LINE ITEM #1
I&T: E CONTRACT NO. = NAS9-1100

PRIORITY	DRAWING TITLE	ENGINEERING ORDER DRAWING NO.	EO NO.
C	CAP D/S UPPER OUTRGR PRESS. VENT. SUPT	LDW280-18198	A1

J ROGERS | J STRAKOSCH x1153
ISSUED BY P. WOSSLITZ SECTION V.D.1. GROUP NO. 335 PL 35
CODE IDENT NO. 26512
GRUMMAN AIRCRAFT ENGINEERING CORP
BETHPAGE, L. I., N. Y.
ENG 32.3 REV 3-65

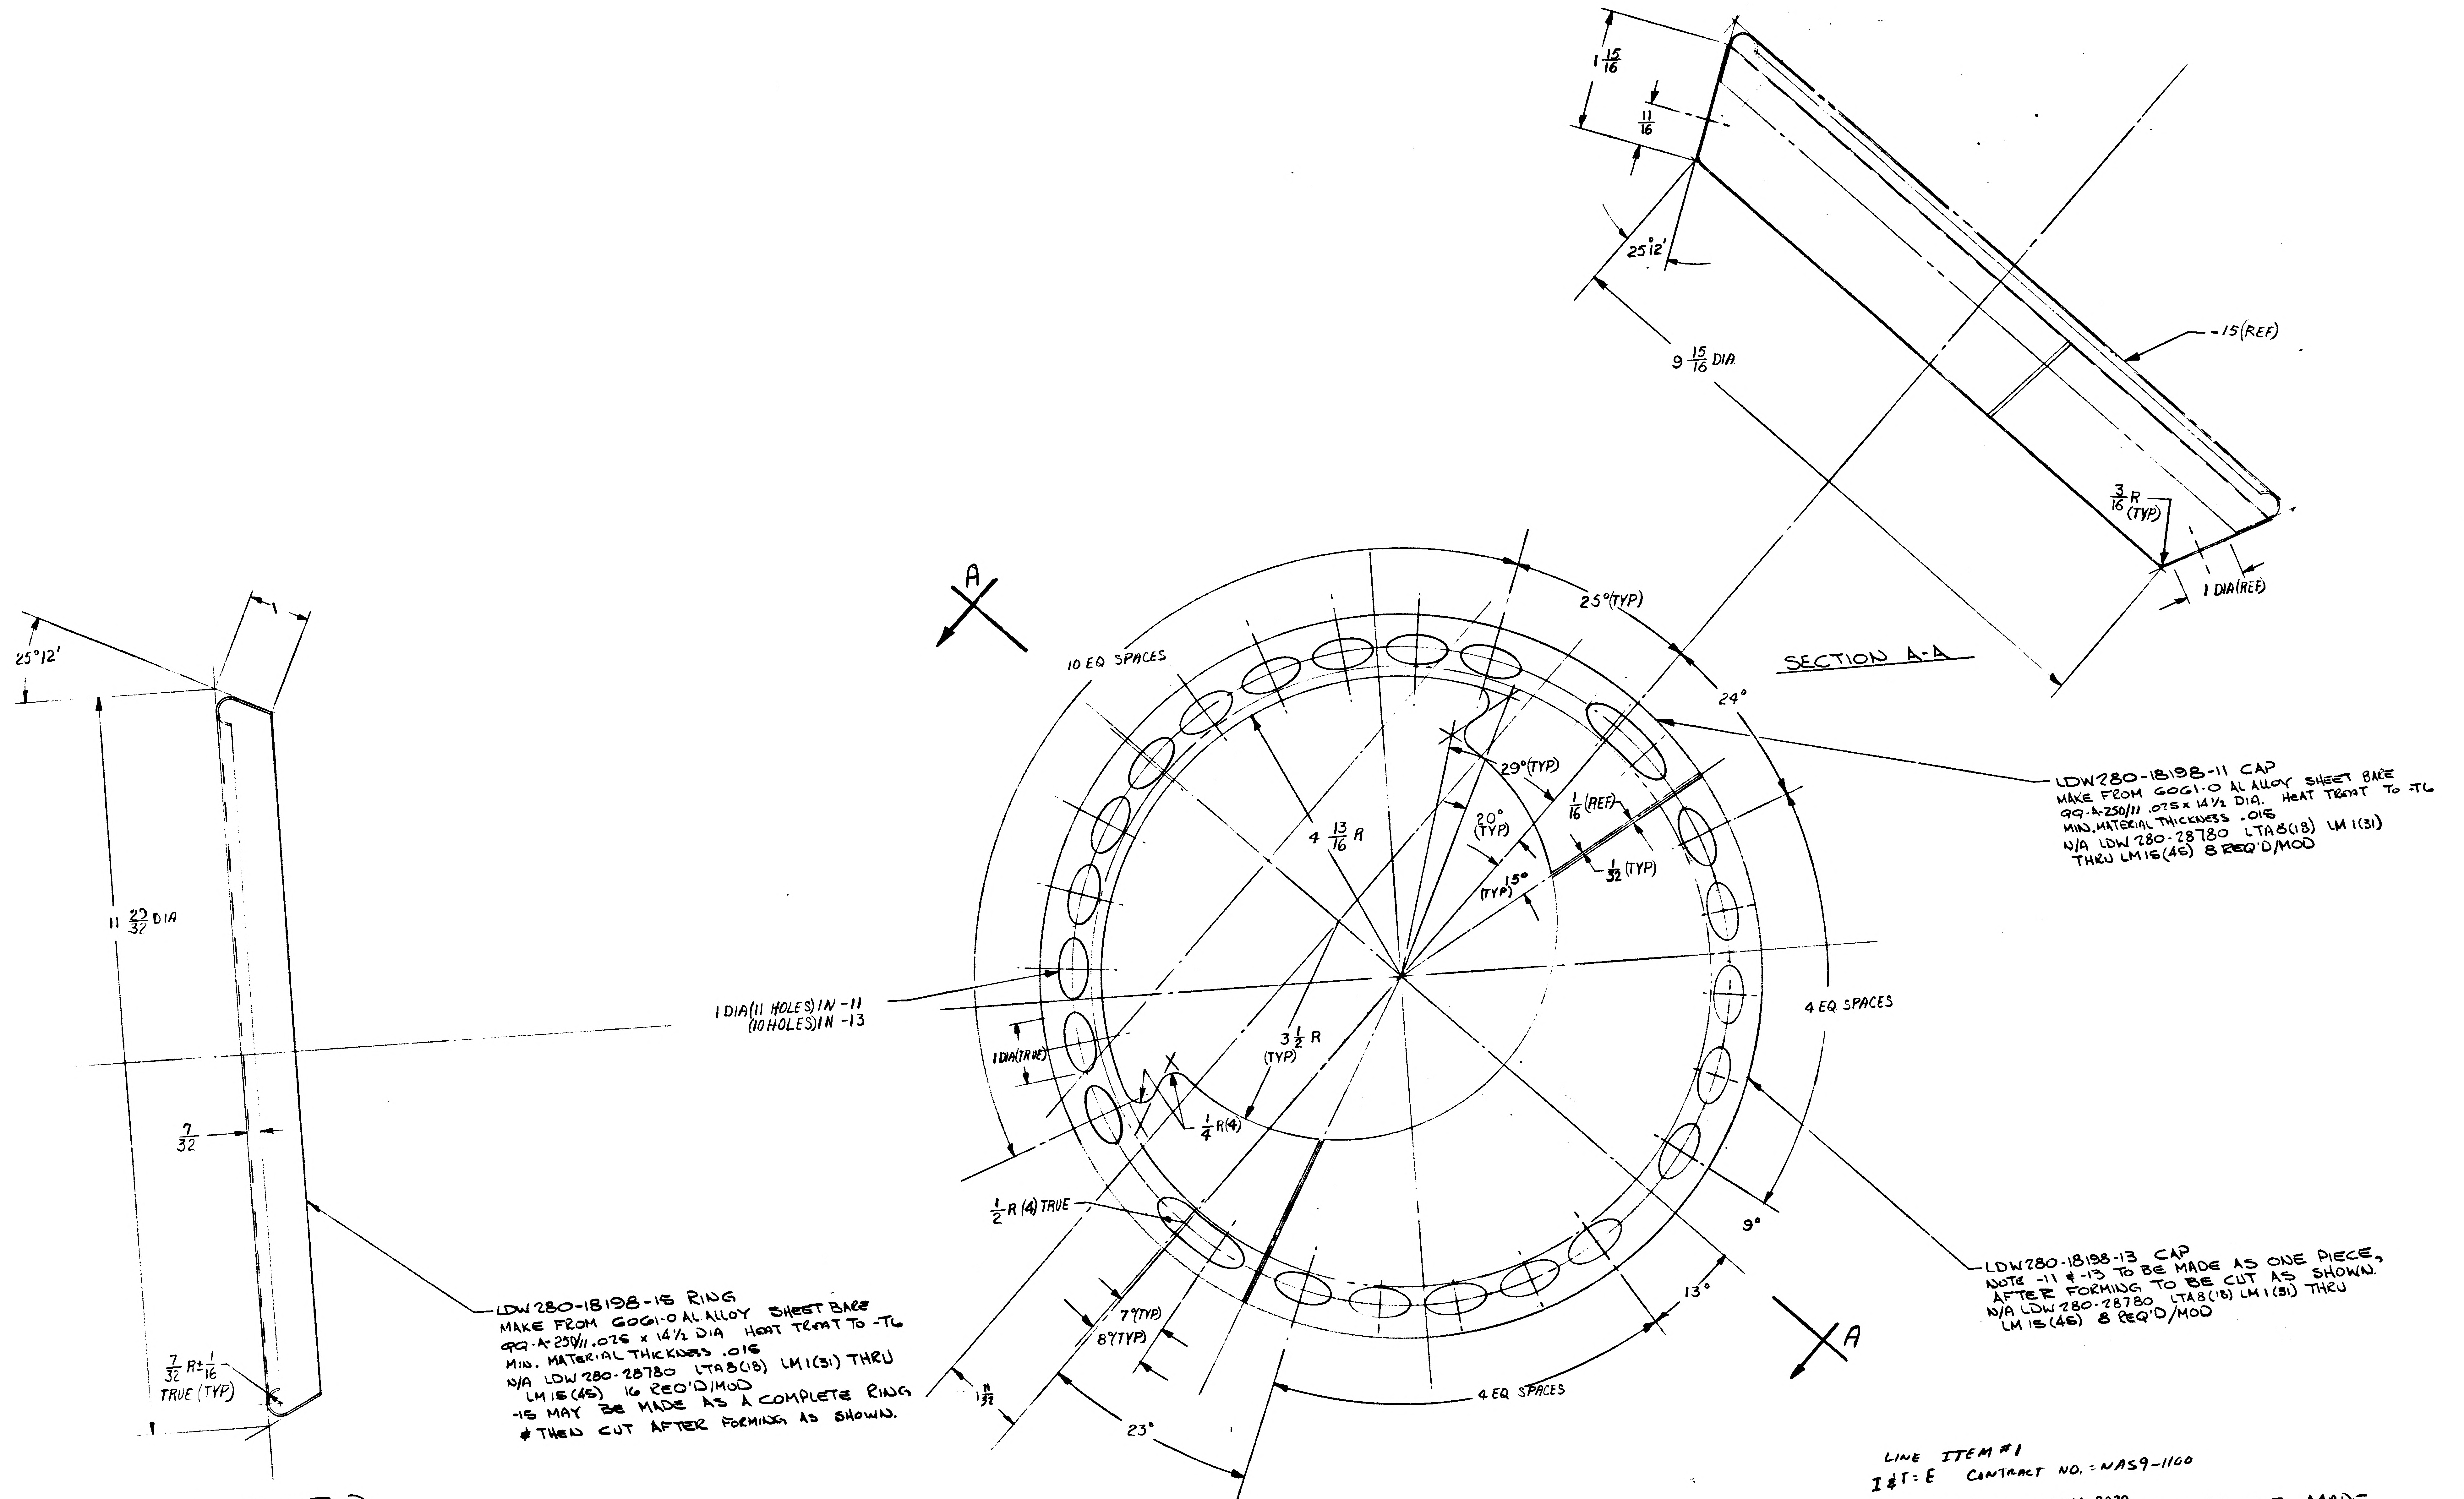
REASON FOR EO	DESCRIPTION OF EO	GRUMMAN EO RELEASE
TO PROVIDE ADEQUATE VENTING (THERMO REQUIREMENT)	E.O. A, INITIAL DRAWING RELEASE PARTS MADE PER E.O	11/17/6 50-1

LDW280-18198-11 CAP
MAKE FROM 6061-O AL ALLOY SHEET BARE
QQ-A-250/11 .025 x 14 1/2 DIA. HEAT TREAT TO -T6
MIN. MATERIAL THICKNESS .016
N/A LDW 280-28780 LTA8(18) LM 1(31)
THRU LM15(45) 8 REQ'D/MOD

LDW280-18198-13 CAP
NOTE -11 & -13 TO BE MADE AS ONE PIECE,
AFTER FORMING TO BE CUT AS SHOWN.
N/A LDW 280-28780 LTA8(18) LM1(31) THRU
LM 15(45) 8 REQ'D/MOD

LDW 280-18198-15 RING
MAKE FROM 6061-O AL ALLOY SHEET BARE
QQ-A-250/11 .025 x 14 1/2 DIA HEAT TREAT TO -T6
MIN. MATERIAL THICKNESS .016
N/A LDW 280-28780 LTA8(18) LM1(31) THRU
LM15(45) 16 REQ'D/MOD
-15 MAY BE MADE AS A COMPLETE RING
& THEN CUT AFTER FORMING AS SHOWN.

LDW280-18134-11 ANGLE
* IDENTICAL TO LDW280-17973-13 EXCEPT FOR LENGTH
.100 7075-T6511 EXTR #69249
1 REQ'D PER VEHICLE FIN #88
N/A = LDW280-23579
LDW280-18134-13 ANGLE
IDENTICAL TO LDW280-17973-13 EXCEPT AS NOTED
.100 7075-T6511 EXTR #69249
1 REQ'D PER VEHICLE FIN #88
N/A = LDW280-23579

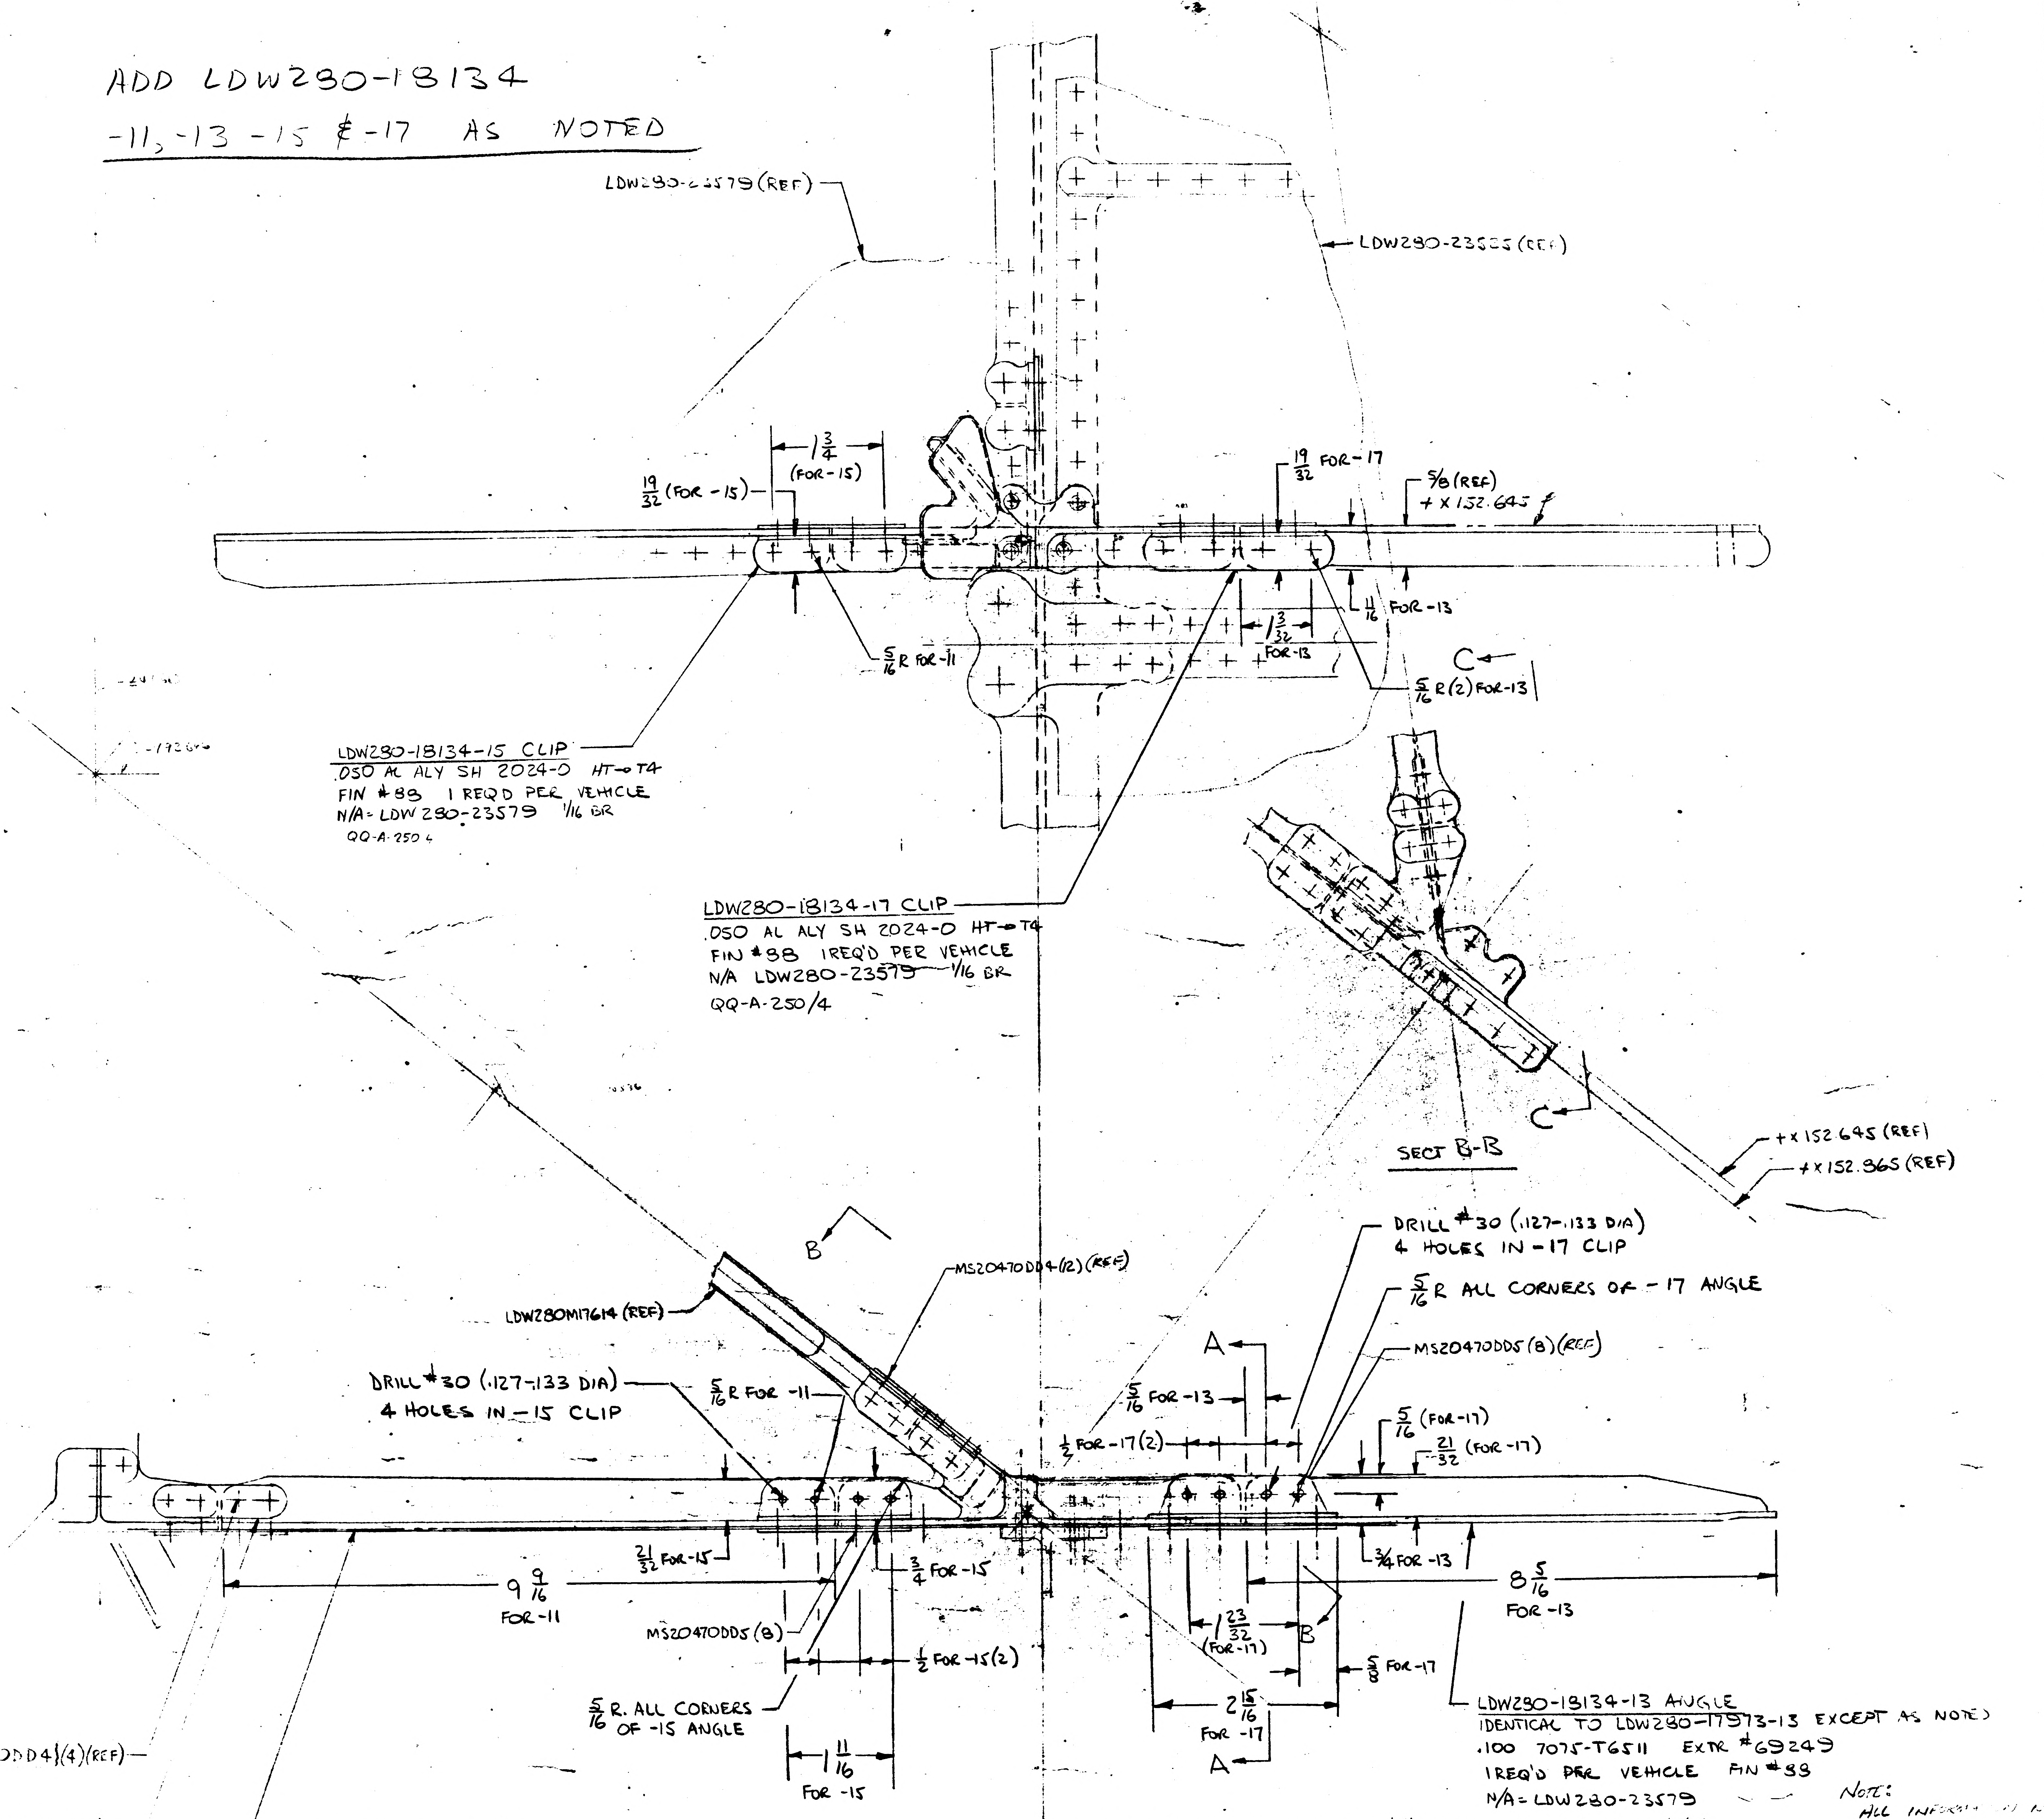
ADD LDW280-18134
-11, -13 -15 & -17 AS NOTED

DETAIL SPEC REQD		CLASS II ENGRG CHG		CLASS I ENGRG CHG	CONTROL INFO NO [illegible]
REASON FOR EO: ADDITION OF RTG FUEL CASK STRUT			DESCRIPTION OF EO: [illegible] PARTS MADE [illegible] EO		GRUMMAN EO RELEASE

* REWORK INFO. -11 ANGLE MAY BE MADE FROM LDW280-17973-13
